IEC 60695-2-10
Edition 3.0 2021-10

**Part 2-10: Glowing/hot-wire based test
methods – Glow-wire apparatus and common
test procedure**

C O R R I G E N D U M 1

Figure C.1 – Times and durations (in accordance with Clause 3)

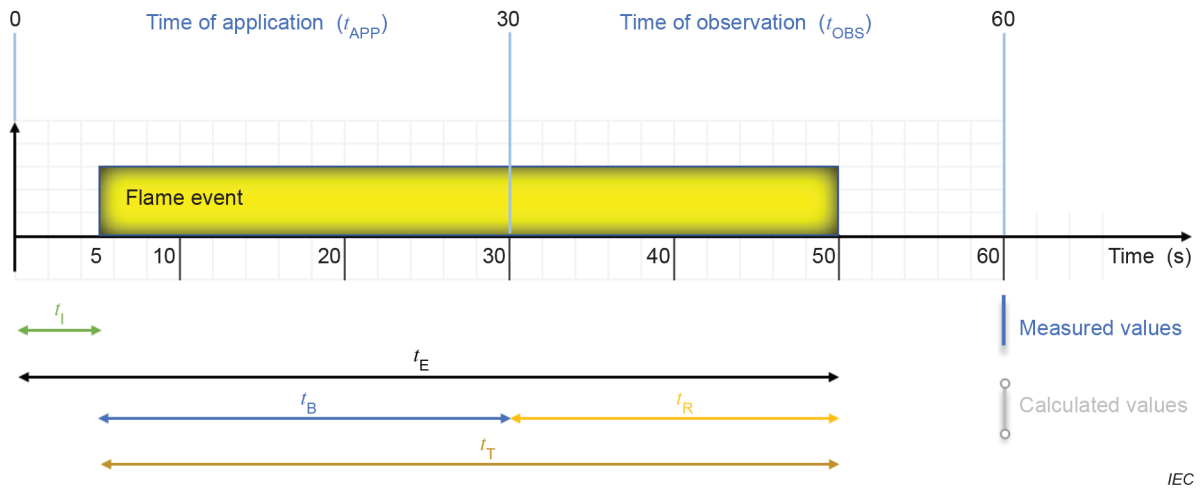
Figure C.1 – Times and durations (Example: ignition occurs at 5 s and extinguishing occurs at 50 s)

Replace the existing title of Figure C.1 with the following new title:

Replace existing Figure C.1 with the following new figure:

Figure C.2 – Evaluation scheme with examples

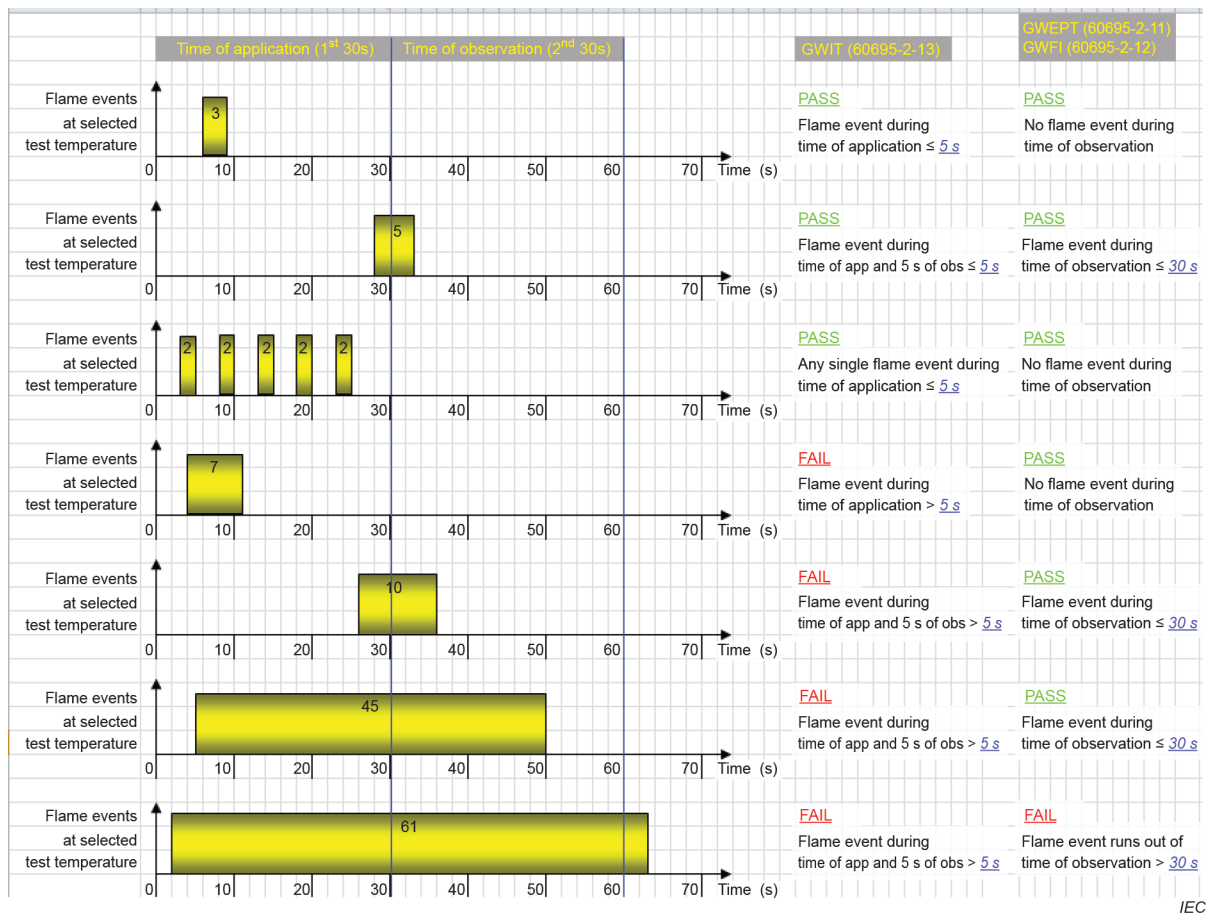
Replace existing Figure C.2 with the following new figure:
